BCA COMPLIANCE ASSESSMENT REPORT

Building Code of Australia 2022 Amendment 2

PROJECT:	64-66 Lavender St, and 3-7 Middlemiss Street Lavender Bay
REF. No.:	NEW250950 (Rev 3)
DATE:	21/04/2026
CLIENT:	Central Element
CONTACT:	Hugh Roberts
EMAIL:	hroberts@ centralelement.com.au
CONSULTANT:	Mauricio Vera
PHONE No:	0451 078 790
EMAIL	mvera@newcrown.com.au

2. Clause C4D3: Protection of openings in external walls.

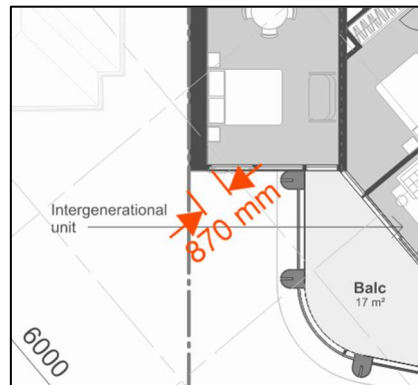
The proposed window is identified to be exposed to a fire-source feature (western boundary) as located within 3m from it and being unprotected, in non-compliance with this clause. In order to protect this exposed opening, a side blade wall achieving the required FRL (90 mins) along the boundary could be proposed. Ensure this wall projects and shows in the drawings.

Design rectification is recommended. Alternatively, Fire Engineer to assess and advise if a Performance Solution is feasible.

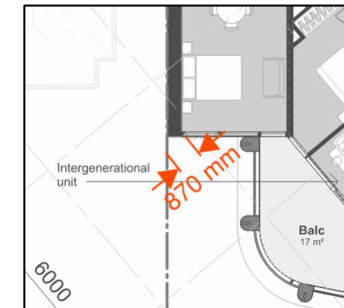
PSOL	(1) Subject to (2), openings in an external wall that is required to have an FRL must be protected in accordance with C4D5, and if wall-wetting sprinklers are used they must be located externally. (2) The requirements of (1) only apply if the distance between the opening and the fire-source feature to which it is exposed is less than— (a) 3 m from a side or rear boundary of the allotment; or (b) 6 m from the far boundary of a road, river, lake or the like adjoining the allotment, if not located in a storey at or near ground level; or (c) 6 m from another building on the allotment that is not Class 10. (3) Openings in an external wall that is required to have an FRL, if required to be protected under (1), must not occupy more than 1/3 of the area of the external wall of the storey in which it is located unless they are in a Class 9b building used as an open spectator stand.	Performance Solution is necessary to achieve compliance with this clause. Opening on external walls exposed (under 3m) to the fire-source feature (side boundary) will require protection as per C4D5. Currently unknown. To be rectified, alternatively Fire Engineer to assess if a Performance Solution is feasible.
